Maryland & Grotto

Station concept

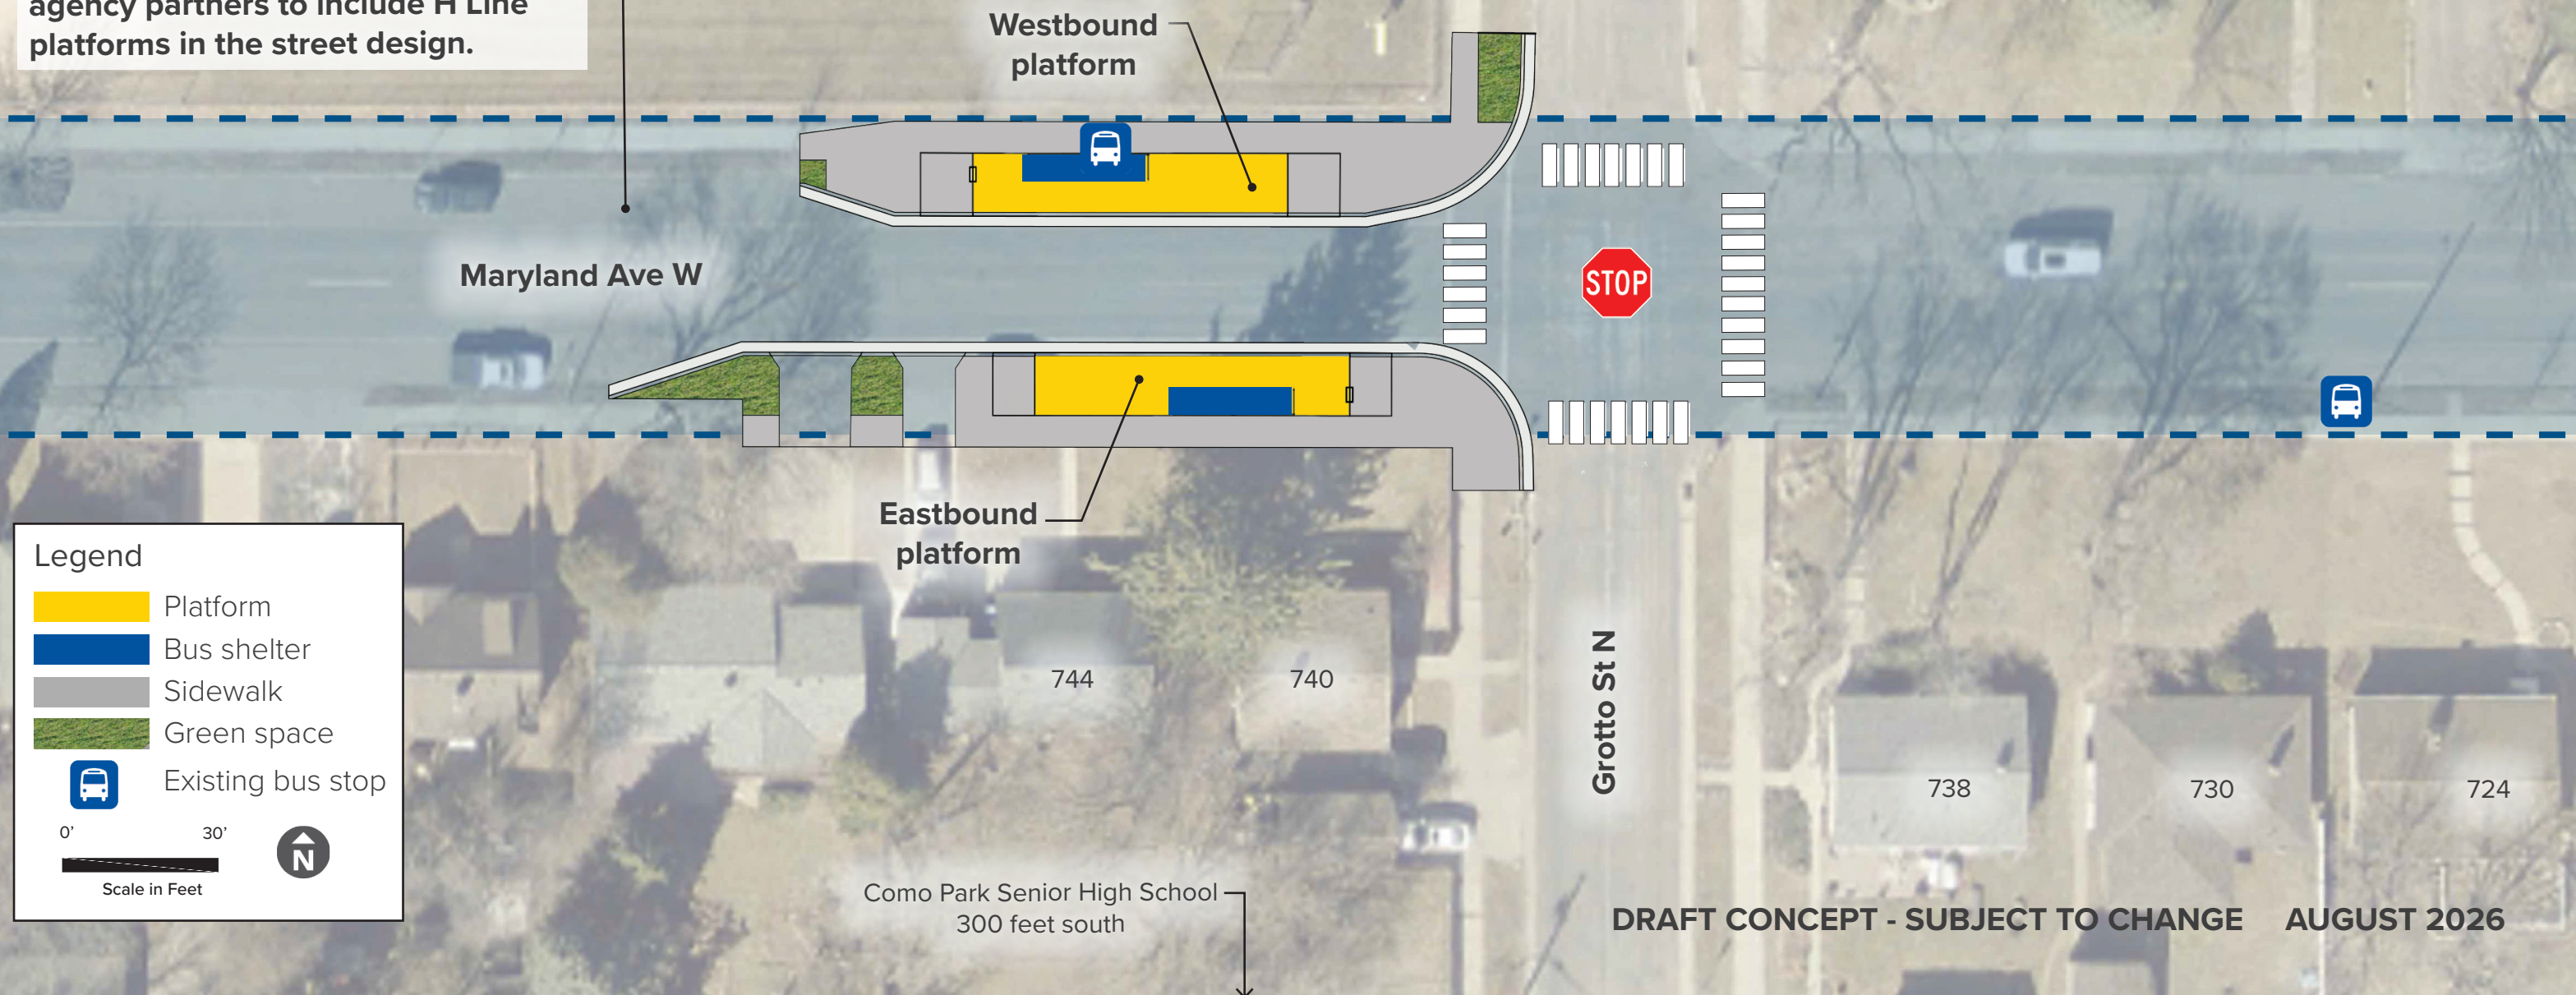
Public feedback received on the Draft Corridor Plan cited concerns about Maryland & Grotto Station westbound platform placement, school traffic and congestion, and student activity in the neighborhood. Absent additional considerations, Metro Transit's preference is to stop nearside at stop sign-controlled intersections so that the bus stops just once—for the stop sign and to load and unload passengers—leading to the placement proposed in the Draft Corridor Plan. Based on public input, H Line project staff evaluated an alternative to move the Maryland & Grotto westbound platform to the farside of the station intersection.

An alternative moving the Maryland & Grotto Station was evaluated:

- Baseline Alternative: Maryland & Grotto Station westbound platform nearside
- Alternative 1: Maryland & Grotto Station westbound platform farside

Following review, Metro Transit project staff recommend moving the Maryland & Grotto Station westbound platform to be farside of the Grotto Street intersection. Moving the platform farside removes the need to cross one leg of Grotto Street, providing safer and more direct access to Como Park Senior High School.
